MONROE COUNTY DRAINAGE BOARD
Tuesday August 13, 2024, at 8:30 AM
Location: Showers Building Room 106D
Hybrid Meeting with Virtual Attendance via Teams

Cutright Boat Storage Preliminary Drainage Comments:

Re: Fry Rd. Residential Project Drainage Plan

CONCEPTUAL DEVELOPMENT PLAN

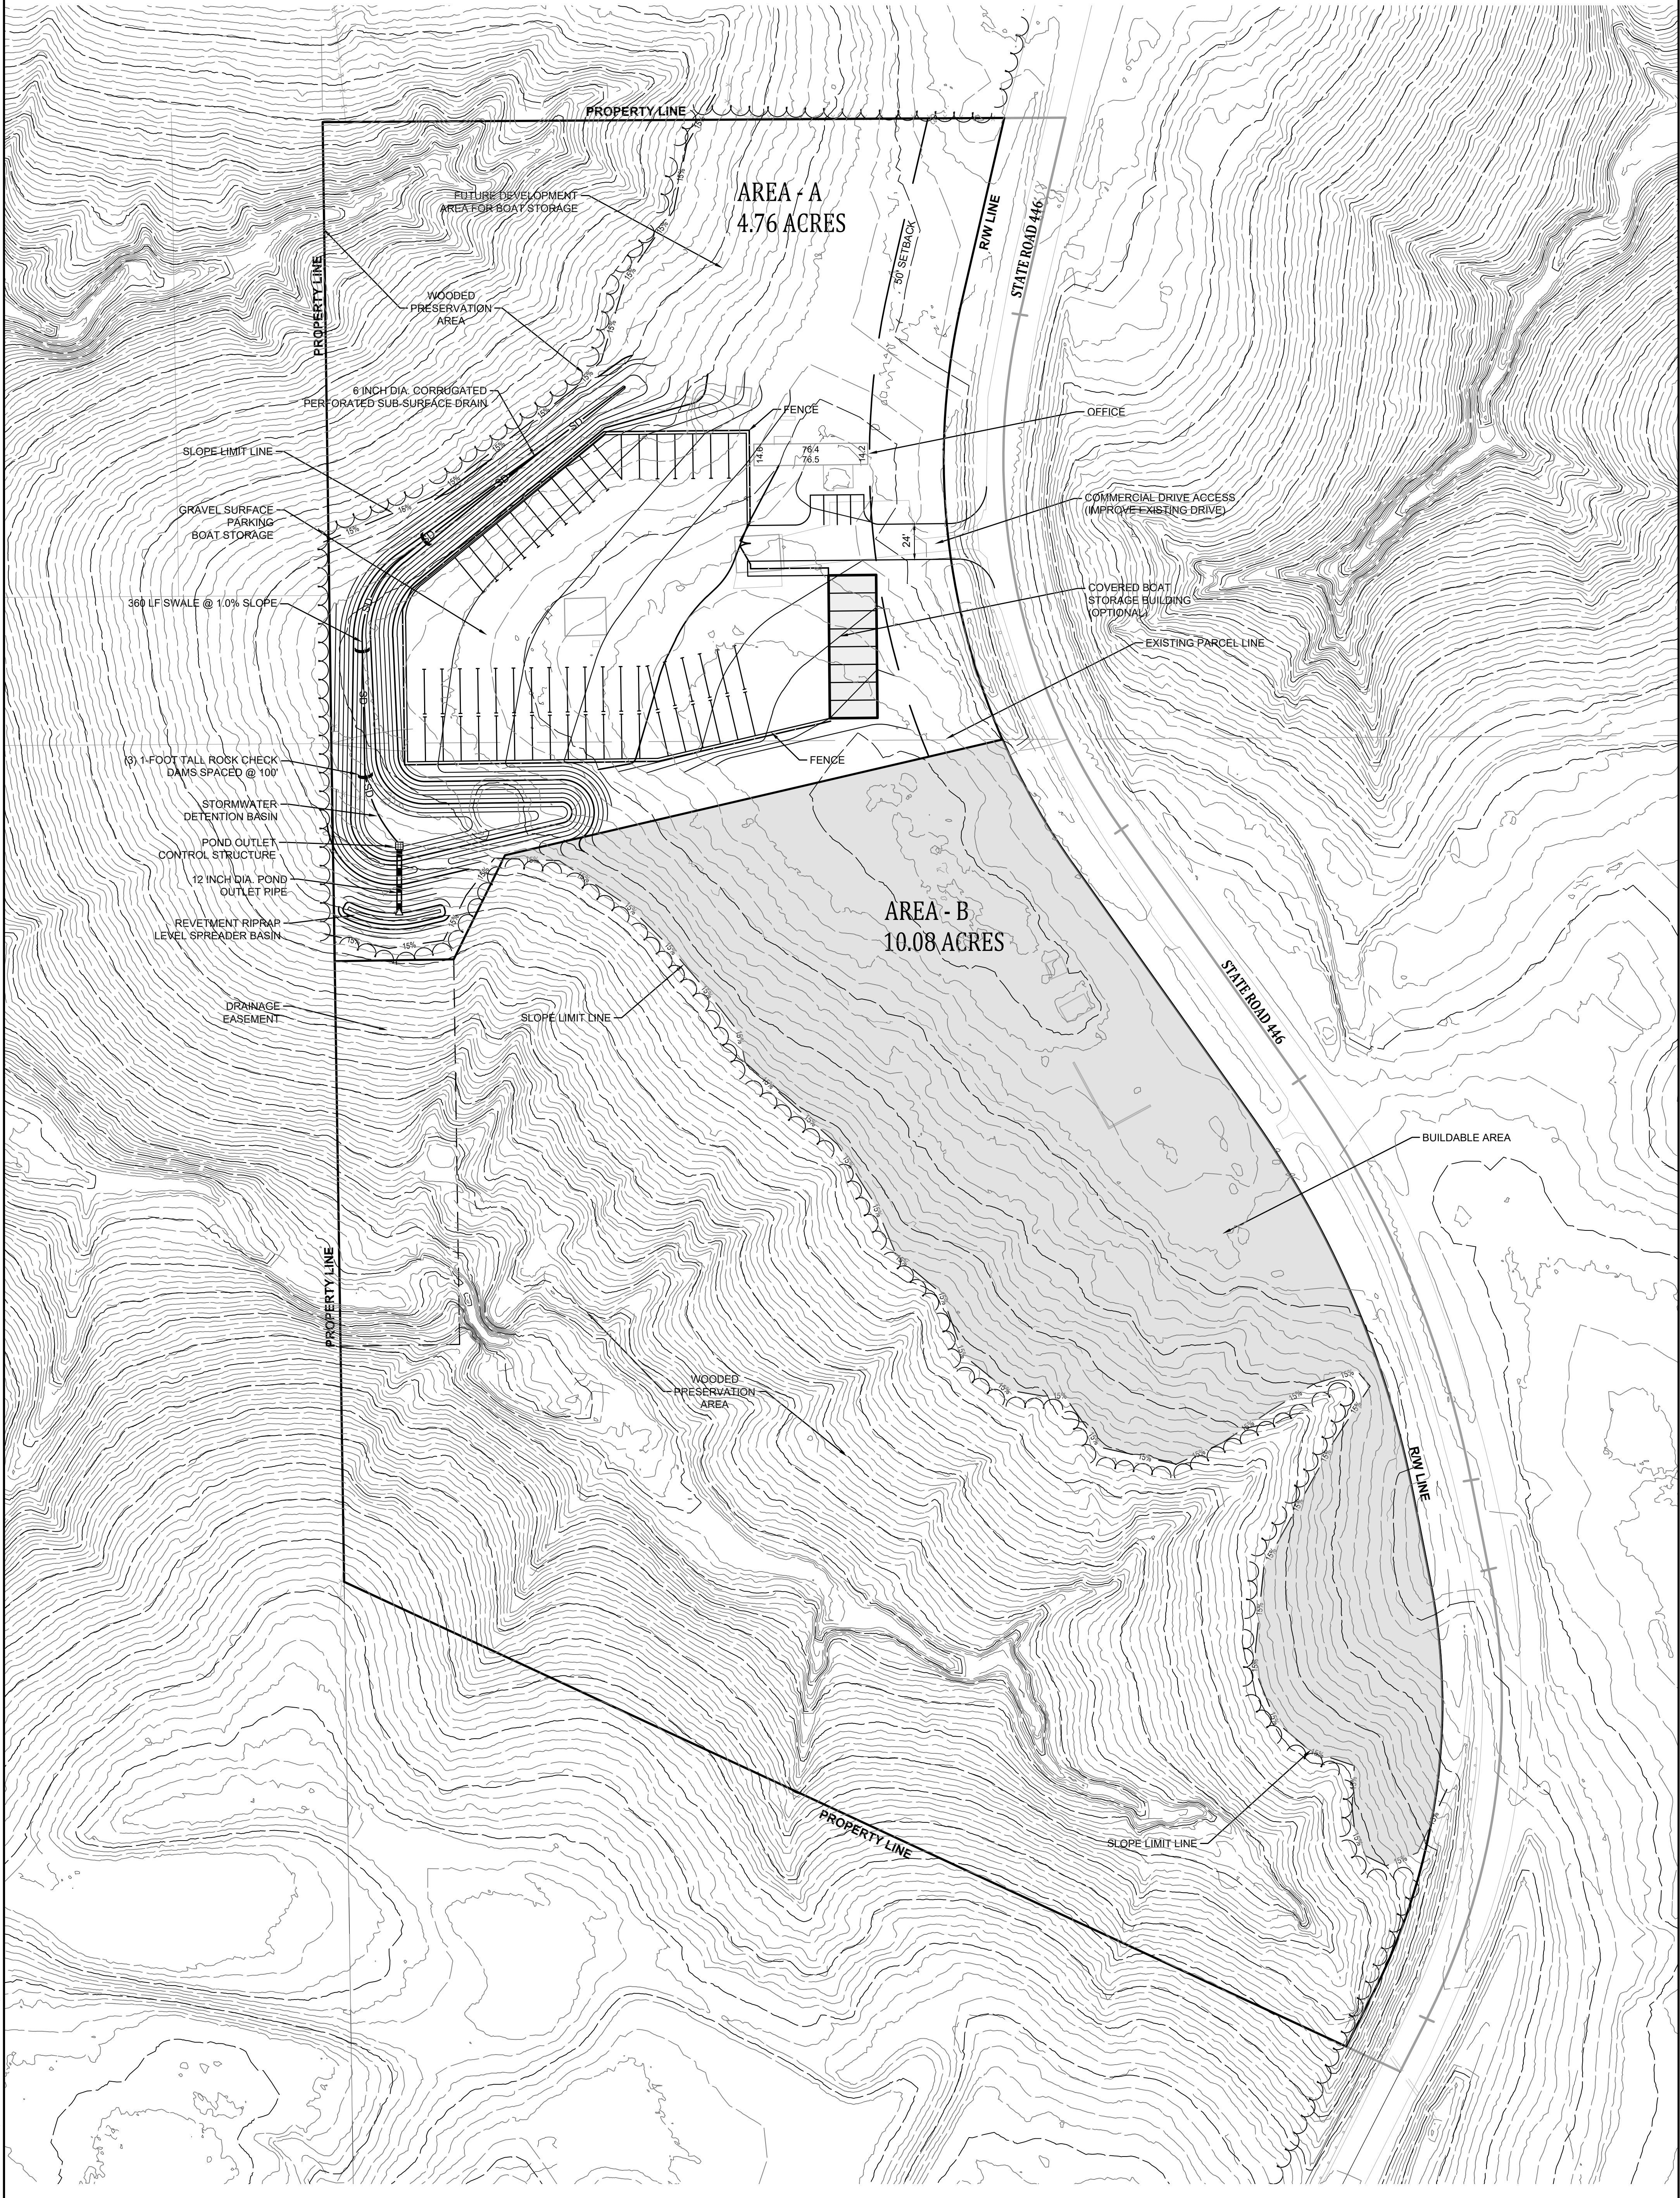
- This project is in the Lake Monroe watershed. General County release rates will be required for detention (0.45 cfs/acre for 10% EP, 0.9 cfs/acre for 1% EP).
- Water quality treatment is required per Ch. 761. Additional water quality measures may be required due to the proposed landuse. This can be determined during development plan review.
- Grass swale with rock check dams and detention basin are proposed as water quality treatment practices.

- Detention basin will outlet to a rip rap stilling basin for velocity dissipation.

- Drainage easements will be required per Ch. 761.

Proposed Conditions

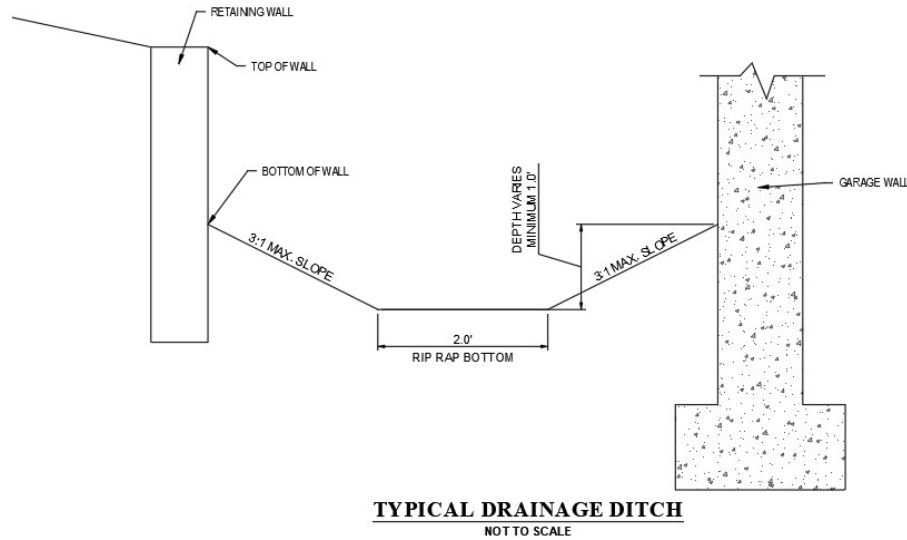
The proposed plan is for a new swale relocation to be constructed on the north side the proposed garage. Below is the typical swale geometry proposed:

The recommendation treatment for the bottom of the swale is rip rap due to the velocity (~10-14 fps) of stormwater. Due to this swale being on the north side of the garage, it may be difficult to establish vegetation within the swale and side slopes and therefore rip rap is recommended on the side slopes as well. However, if vegetation is able to be established to stabilize the side slope and even bottom of the swale without causing erosion, vegetation could be used.

FIGURE
5

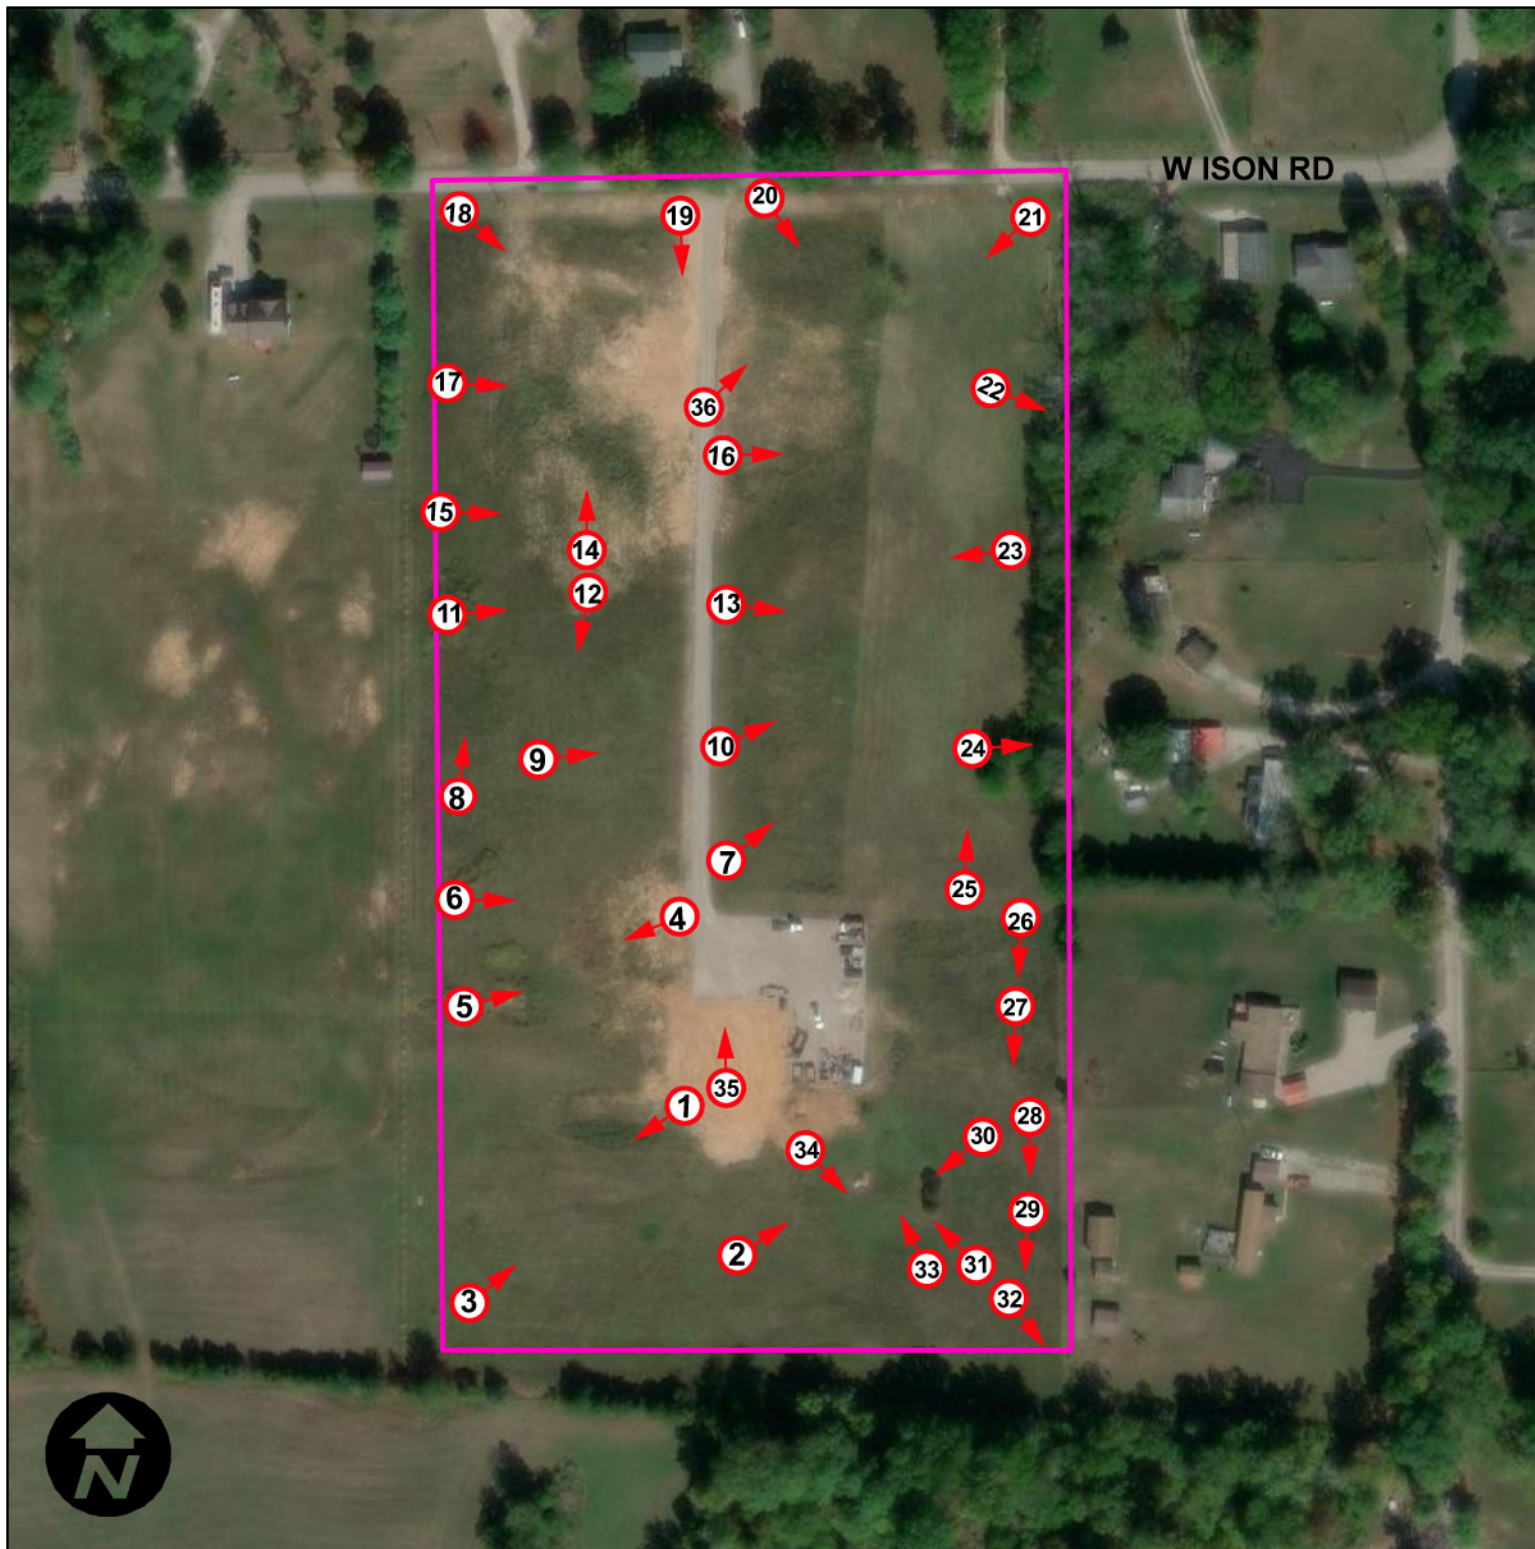
SH-01 Mitigation – SH-01 should receive a sinkhole conservancy area (SCA) in accordance with Monroe County Planning guidelines. The location of the SCA should be based on a Site survey. The gravel driveway and parking area at the Site encroach on approximately 0.10 acres of the sinkhole. No impacts from the driveway or parking area to the sinkhole were observed during the field review. SH-01 should be protected with erosion and sediment control measures during any future development near the sinkhole.

SH-02 Mitigation – SH-02 should receive an SCA in accordance with Monroe County Planning guidelines. The location of the SCA should be based on a Site survey. SH-02 should be protected with erosion and sediment control measures during any future development near the sinkhole.

SH-03 Mitigation – SH-03 should receive an SCA in accordance with Monroe County Planning guidelines. The location of the SCA should be based on a Site survey. The parking area at the Site encroaches on approximately 0.01 acres of the sinkhole. No impacts from the parking area to the sinkhole were observed during the field review. The areas of disturbed soil within SH-03 should be graded and seeded to prevent impacts to the sinkhole. SH-03 should be protected with erosion and sediment control measures during any future development near the sinkhole.
